AGENDA

The Columbia Architectural Design Review Team will meet on Tuesday, June 7th, 2022 at 8:00 a.m. in Conference Room A on the basement level of City Hall, 700 N. Garden Street to consider the following:

8:10 AM 22-0119 - 2008 Main Street - Modify Façade Of Existing Building
Request from Richard Thompson on behalf of Ritco Group, Inc for façade
modifications at [2008 S. MAIN STREET.](#)

Sheet Name
EXTERIOR ELEVATIONS

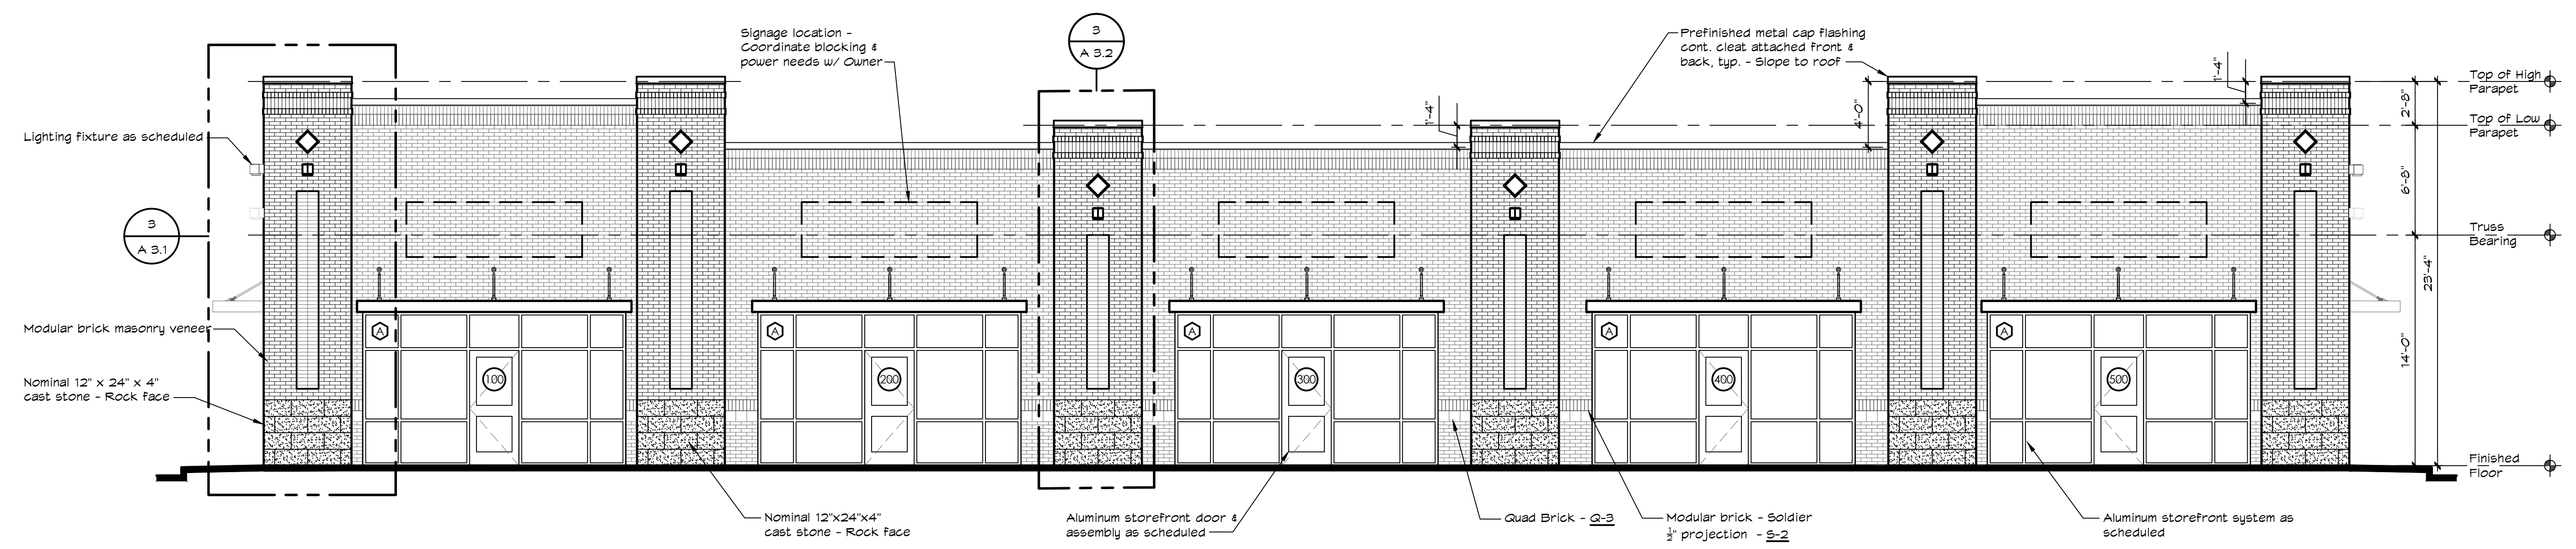
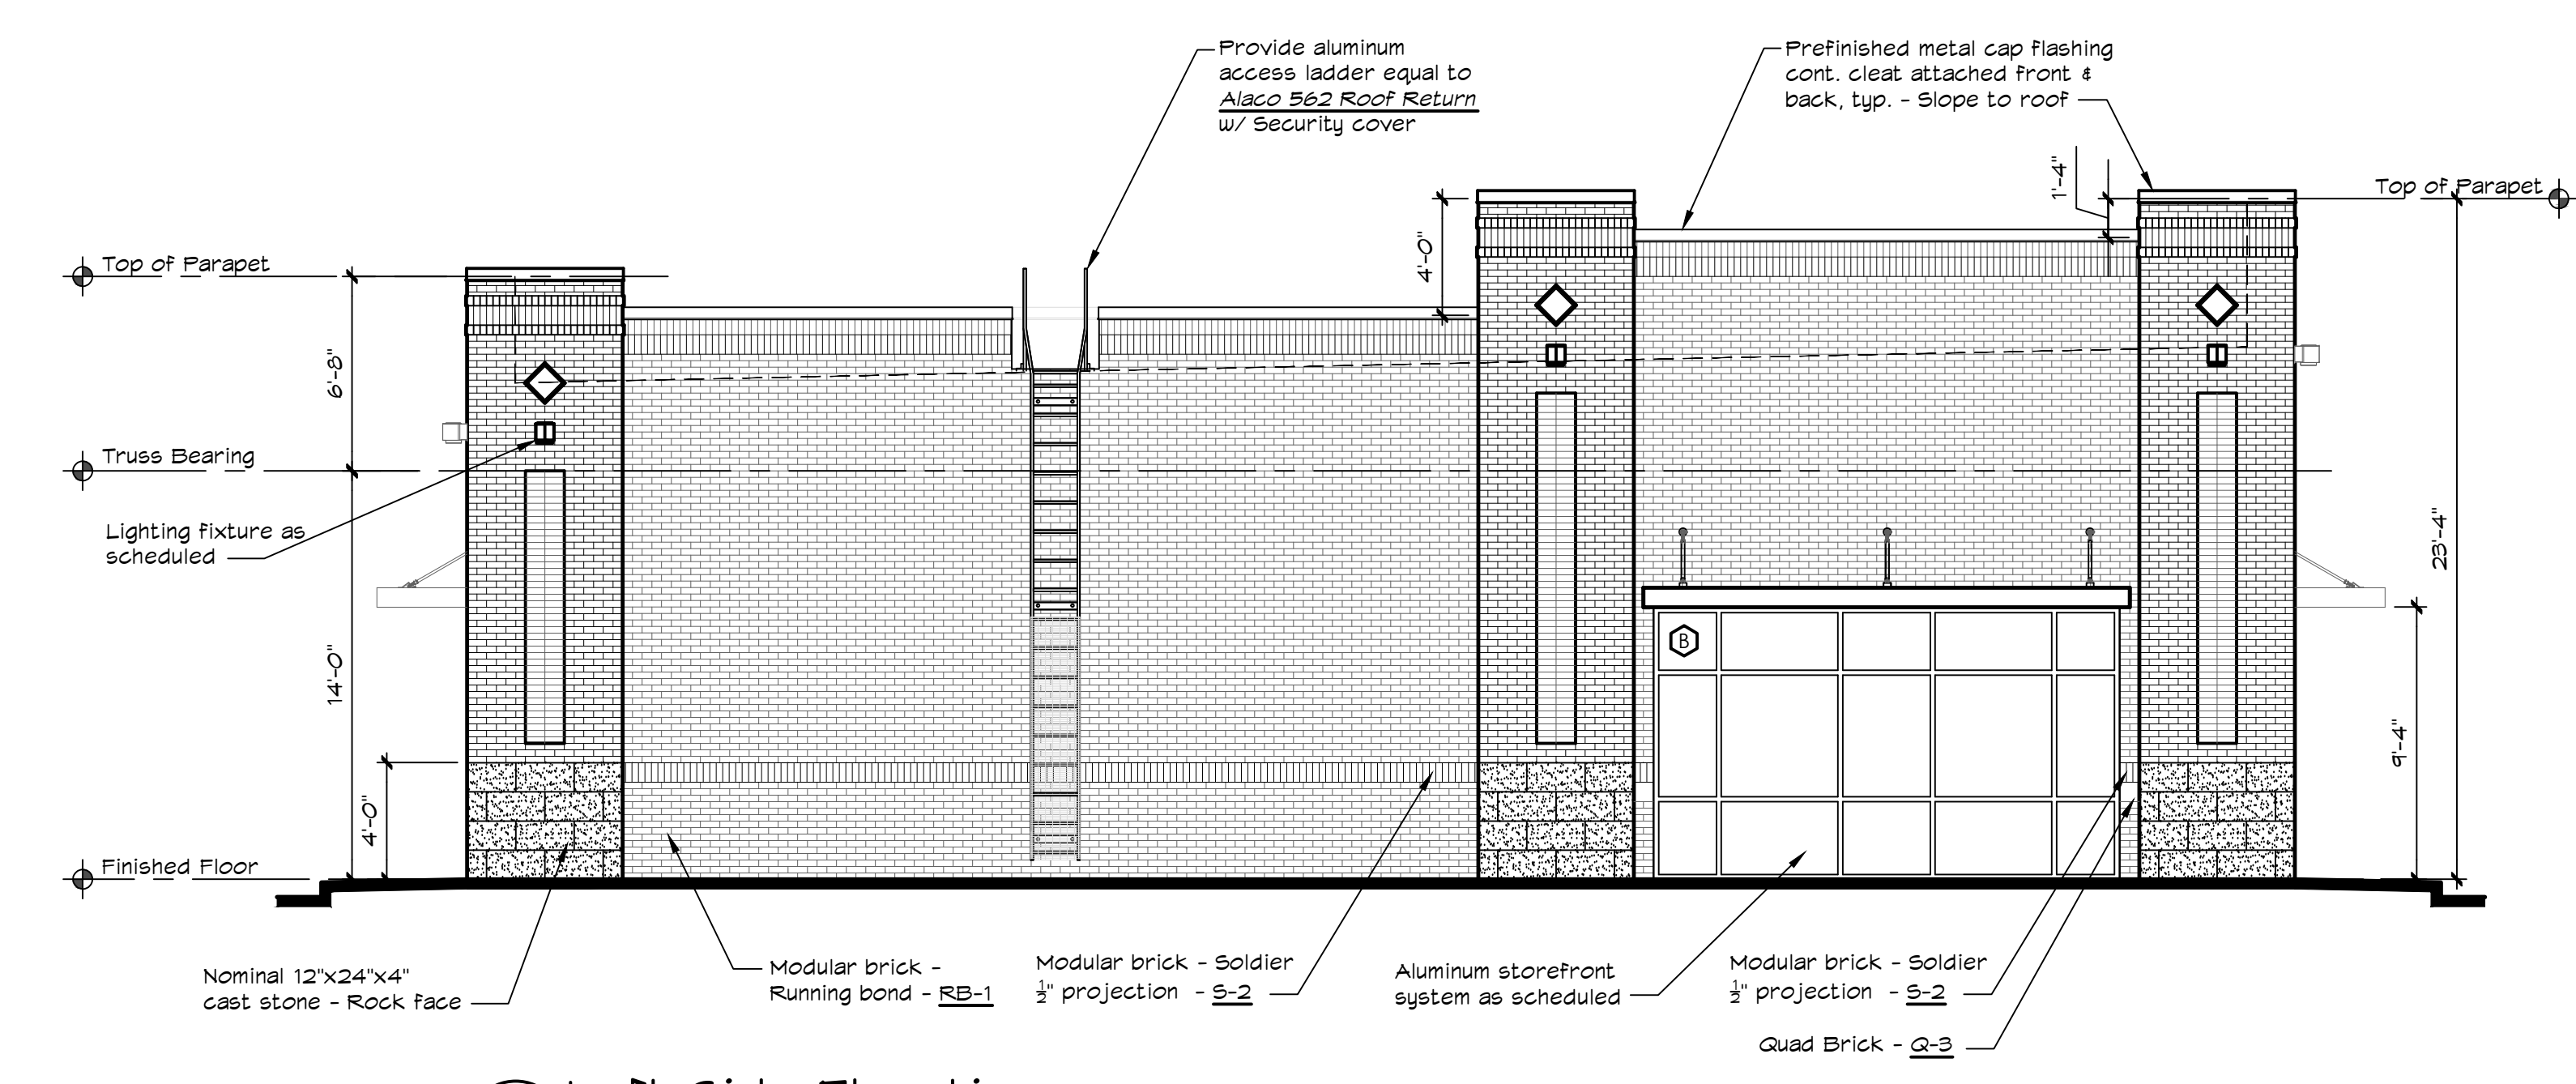
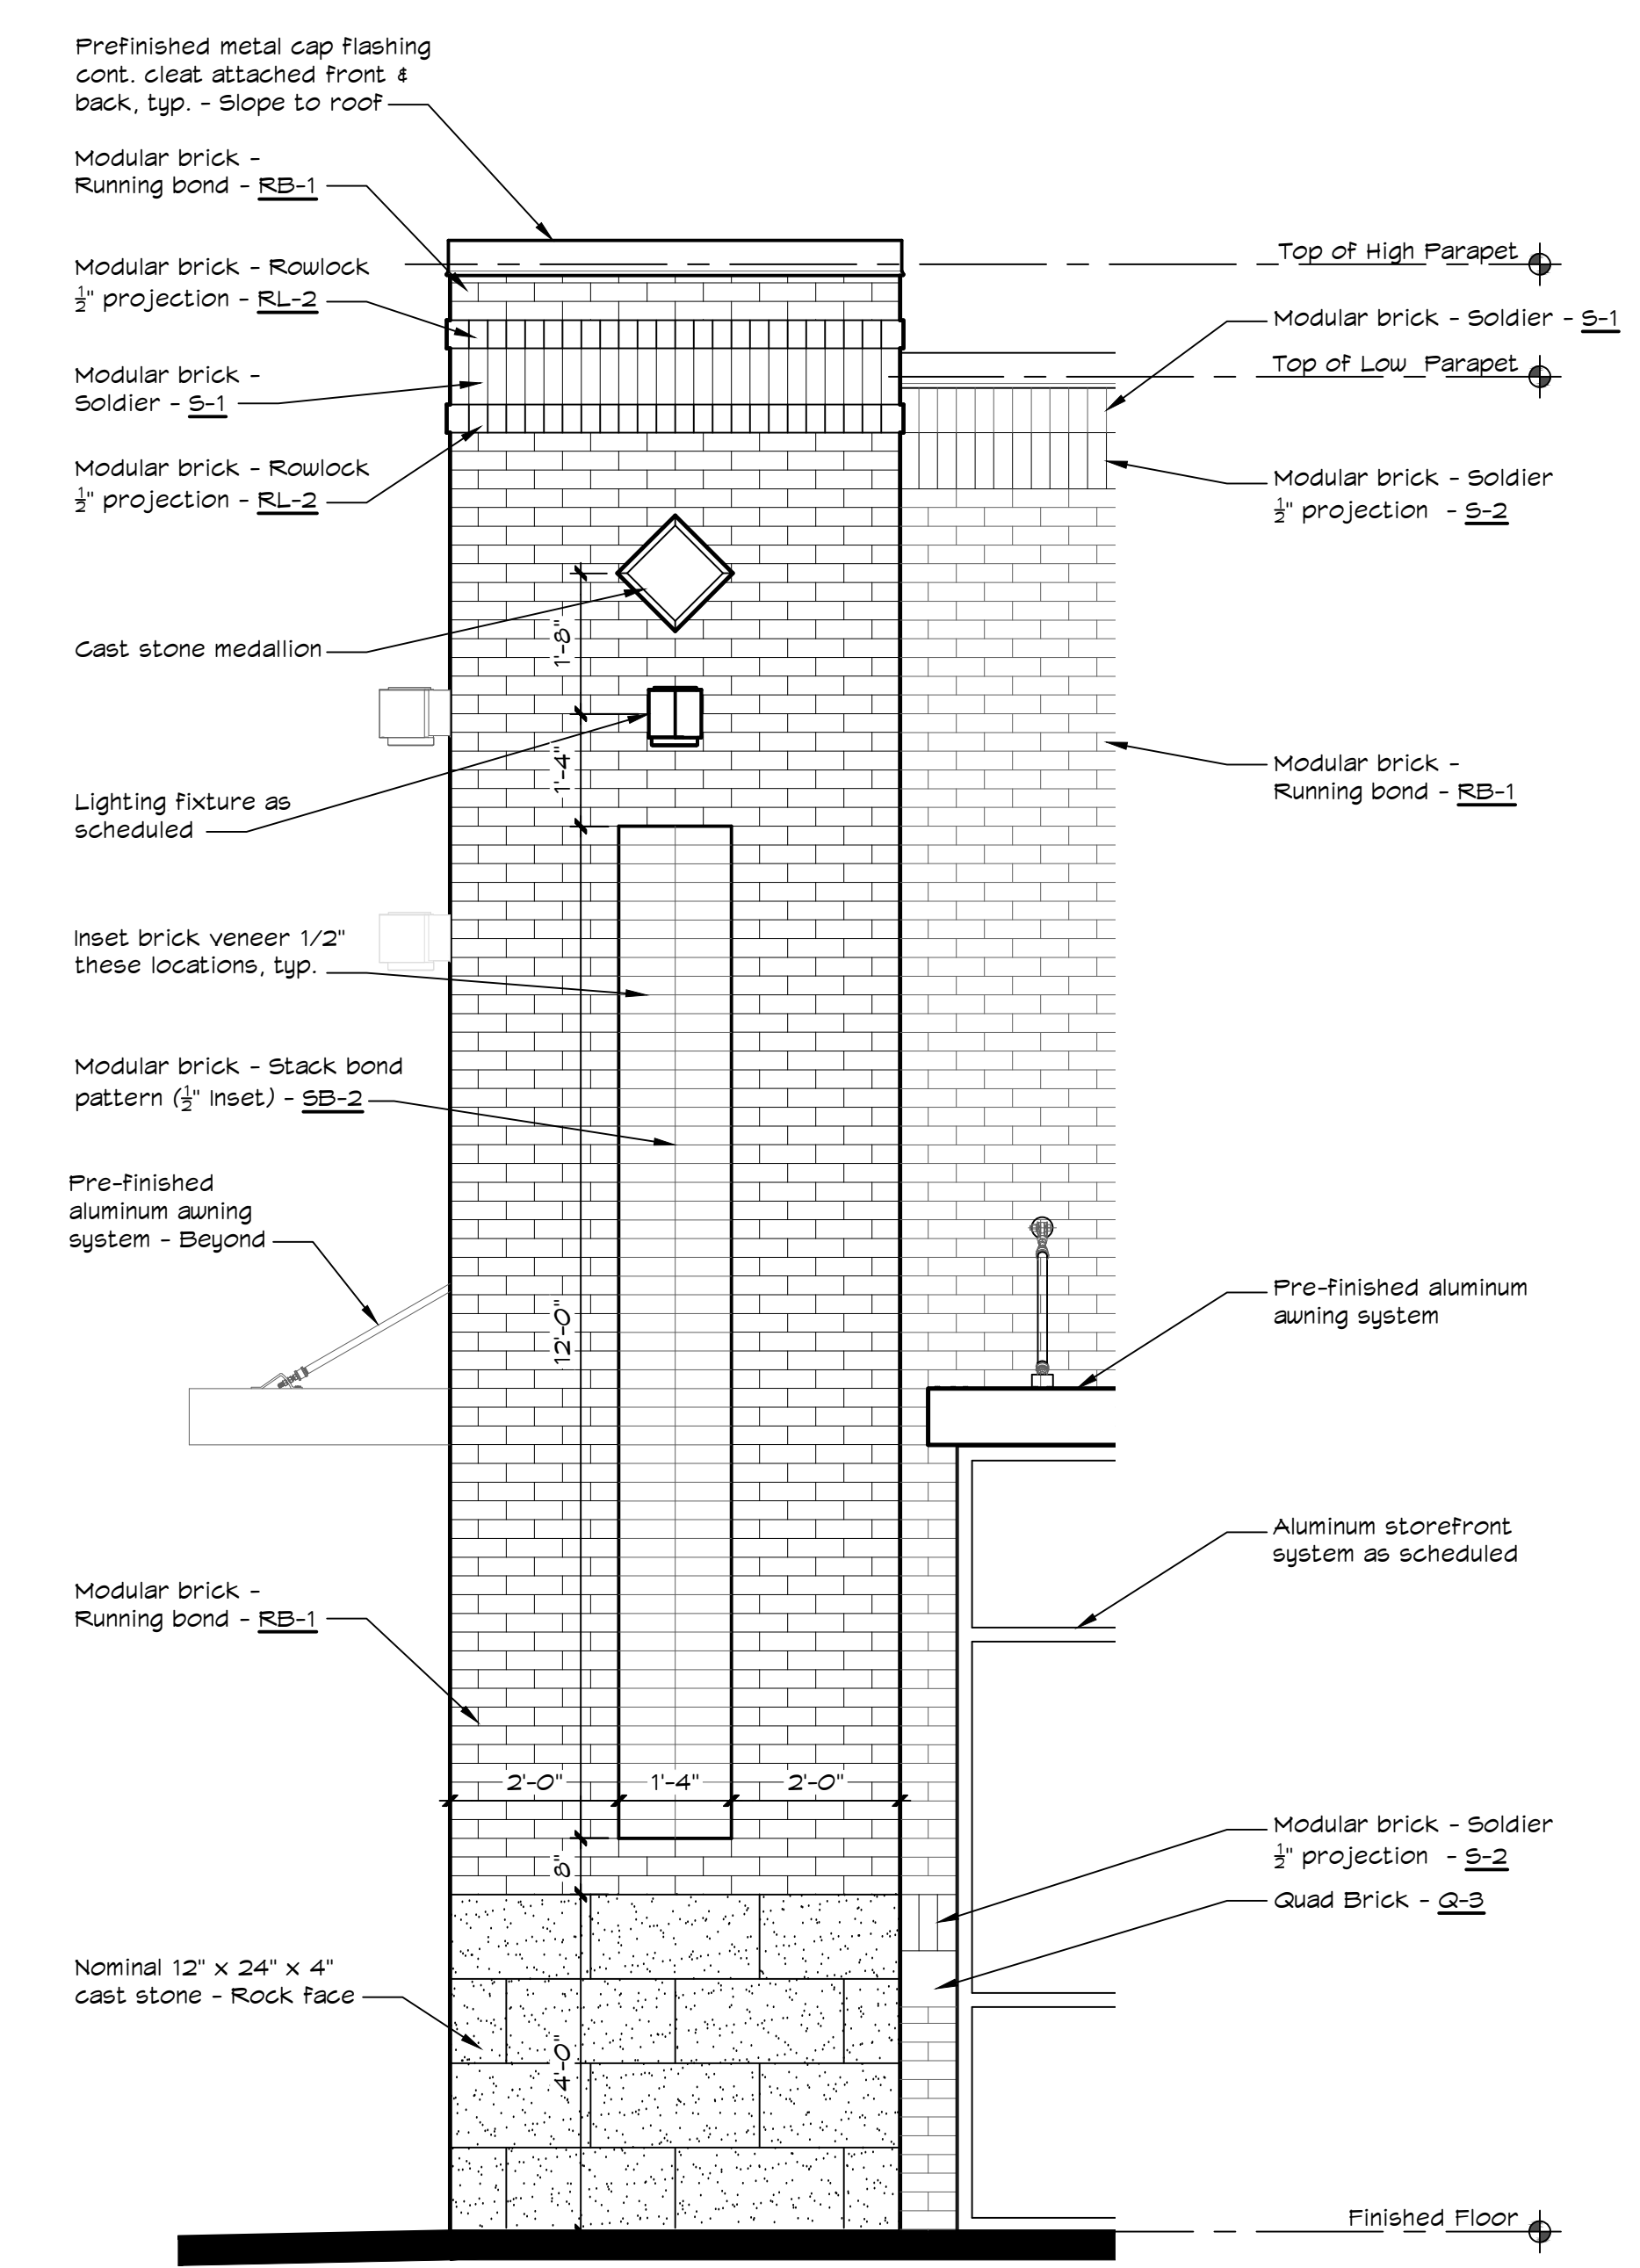
- The proposed west (rear) building elevation will consist of a primary façade material of brick accented by brick soldiering within the base and the columns. Each individual pilaster will be accented by a stone medallion detail. Aluminum storefront windows will be facing the Cayce Lane elevations. The front elevation will consist of the same primary façade materials as the rear elevation with a combination of brick details separated by brick pilasters.
- The right and left (side) elevations will consist of a primary brick material as all other elevations with a 4' recessed parapet.
- It shall be recommended that as a condition of approval that all rooftop HVAC equipment be screened by the raised parapet with no exterior visibility.
